**RE: Field Issue of deck beam support for Lot #125 Manor at Stoney Creek – 1920 SW Merryman Dr.
Lee's Summit, MO 64082 – Permit # PRRES20214879**

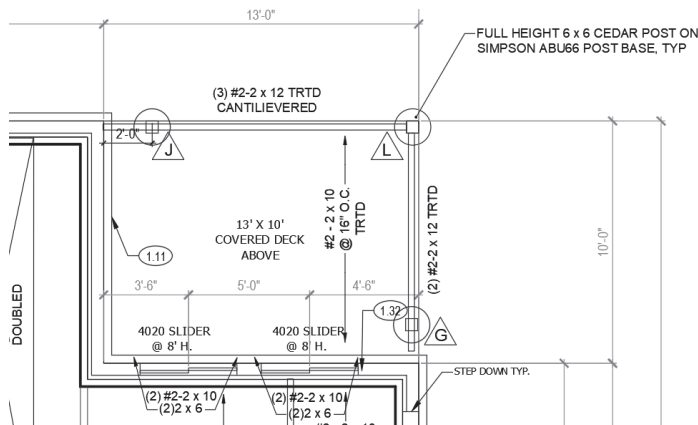
- Inspector Comment #1: Provide approved hanger at triple and double deck beam to ledger connection at deck.

- Approved hanger not installed at deck beam connection to corner of house.
- Approved hanger not installed at double joist at deck end joist.

- Install full height 6x6 cedar post on Simpson ABU66 post base with "J" and "G" size footing as shown in image below:
